# Region School District 14 Nonnewaug High School Renovations Project

# **Geotechnical Engineering Services**

RFP: #2016-009

Addenda #1 – September 20, 2016

AE005

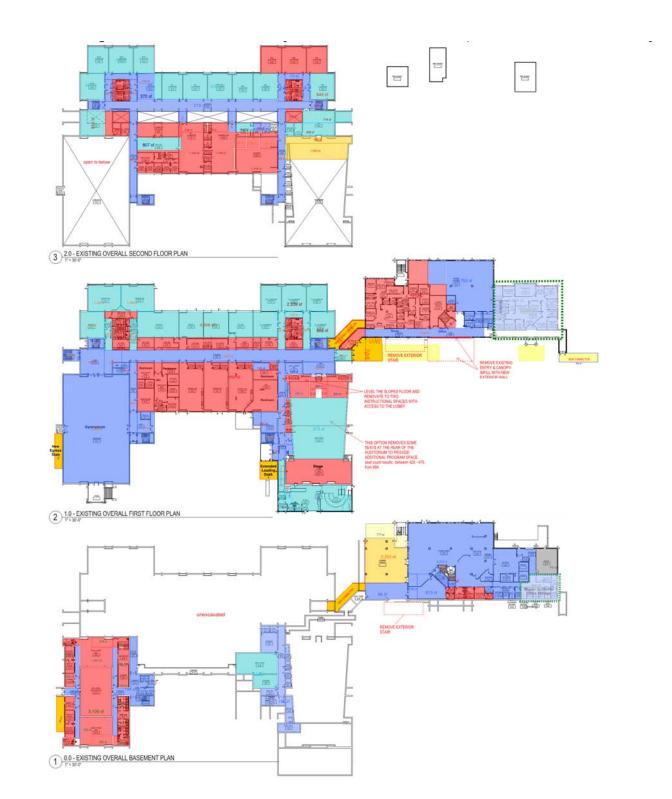
ITEM #2: What types of additions are anticipated and what are the borings and test pits for.

- The 3 borings adjacent to the middle portion of the existing building are for corridor and vestibule additions.
- The two borings to the north are for a loading dock addition and a new egress stair from the gymnasium
- The field borings are for new bleachers along with concrete stairs and ramps for handicapped accessibility to the fields.
- Test pits will be used to establish existing pavement and subgrade sections.
